Project	IEEE 802.16 Broadband Wireless Access Working Group < http://ieee802.org/16 >
Title	Power Saving Classes objects
Date Submitted	2006-04-18
Source(s)	Joey Chou [mailto:joey.chou@intel.com] Intel Corporation 5000 W. Chandler Blvd. Chandler, AZ 85226
Re:	
Abstract	This contribution proposed the text and ASN.1 code for Power Saving Classes objects.
Purpose	Adoption
Notice	This document has been prepared to assist IEEE 802.16. It is offered as a basis for discussion and is not binding on the contributing individual(s) or organization(s). The material in this document is subject to change in form and content after further study. The contributor(s) reserve(s) the right to add, amend or withdraw material contained herein.
Release	The contributor grants a free, irrevocable license to the IEEE to incorporate material contained in this contribution, and any modifications thereof, in the creation of an IEEE Standards publication; to copyright in the IEEE's name any IEEE Standards publication even though it may include portions of this contribution; and at the IEEE's sole discretion to permit others to reproduce in whole or in part the resulting IEEE Standards publication. The contribut

19 **Figure 7— wmanIfBsCps structure**

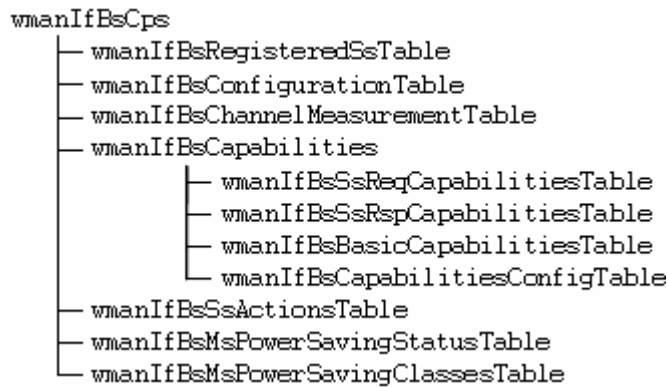
7 This section proposes new table for Power Saving Classes.

9 *[Insert a new subclause 15.2.1.1.2:]*

11 **15.2.1.1.2 wmanIfBsCps**
